# UNITED STATES PATENT AND TRADEMARK OFFICE

APPLICATION NO.	FILING DATE	FIRST NAMED INVENTOR	ATTORNEY DOCKET NO.	CONFIRMATION NO.
10/072,872	02/12/2002	Yoshie Kanamori	100021-00069	2414

<b>Office Action Summary</b>	<b>Application No.</b> 10/072,872	<b>Applicant(s)</b> KANAMORI ET AL.	
	<b>Examiner</b> Long Nguyen	<b>Art Unit</b> 2816

## DETAILED ACTION

Fig. 27

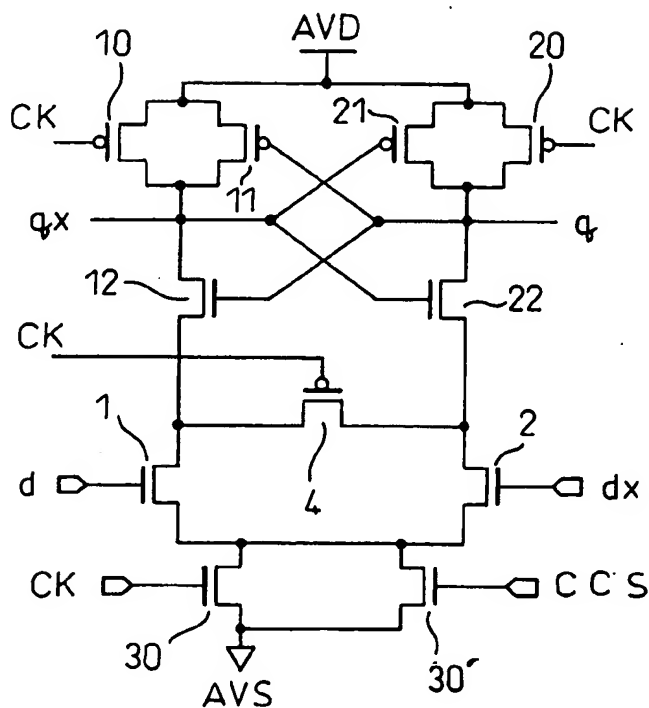
Not approved!  
Do not enter!  
4/26/05 LN

Fig. 28

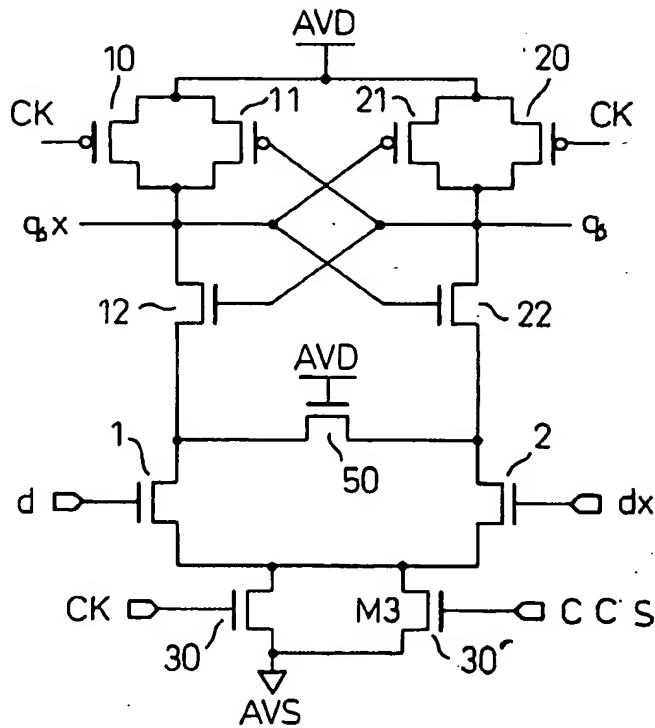
Not approved!  
Do not enter!  
4/26/05 W

Fig. 29.

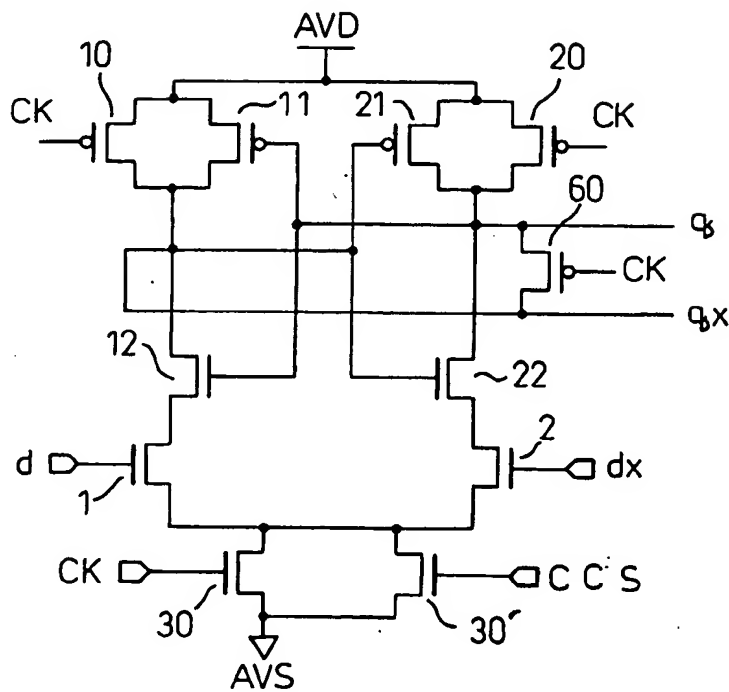
2. The amended to the specification filed on 3/21/05 is still objected to because the reaction "Fig. 29 is a circuit ... the invention;" on line 9-10 of page 2 of the amendment 3/21/05 is not line-through so the above recitation is not deleted and thus it still causes the new-matter's objection to the specification as discussed in the final office action mailed on 9/22/04. Appropriate correction is required.

Fig. 30

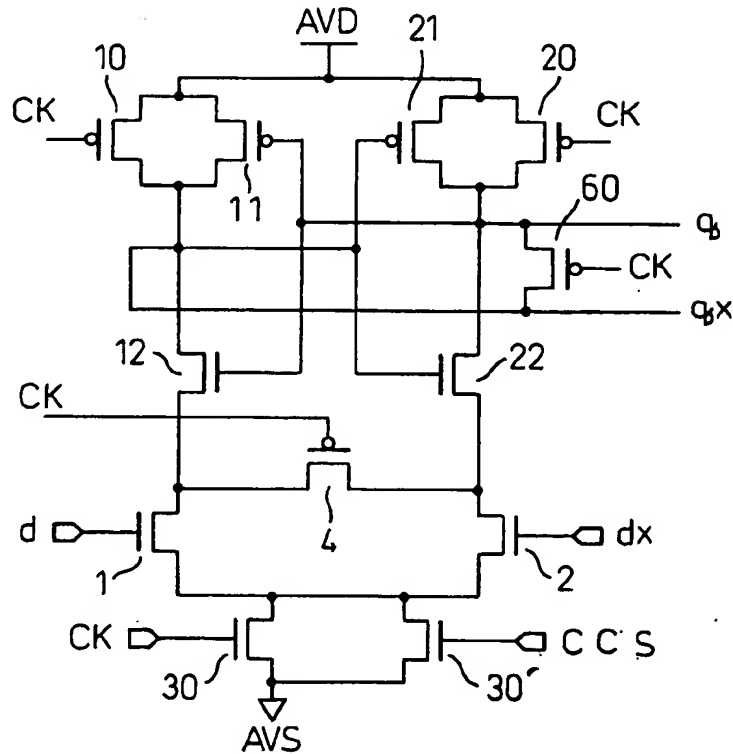
Not approved!  
Do not enter!  
24/26/05 2W

Fig. 31

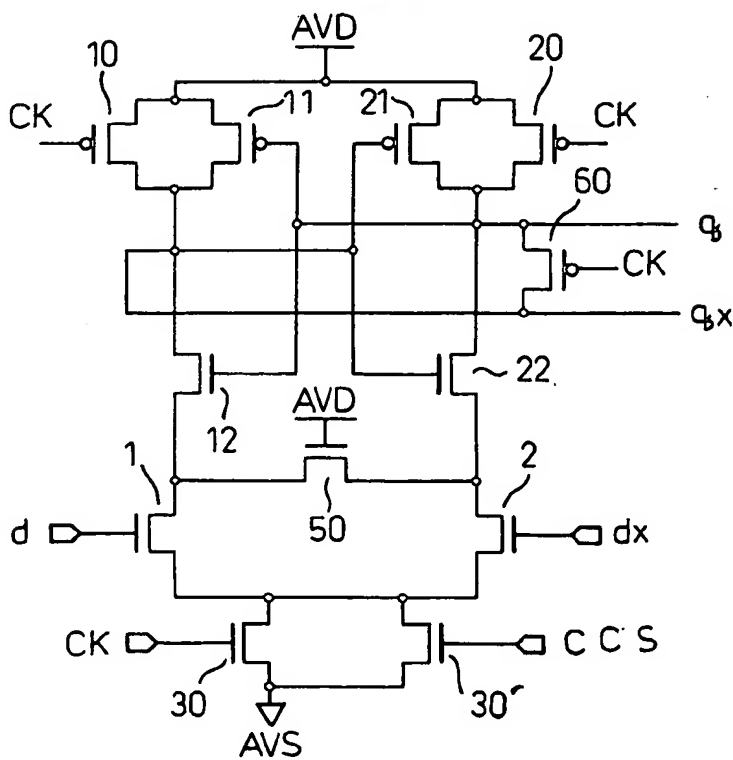
Not approved!  
Do not enter!  
4/26/05 LW
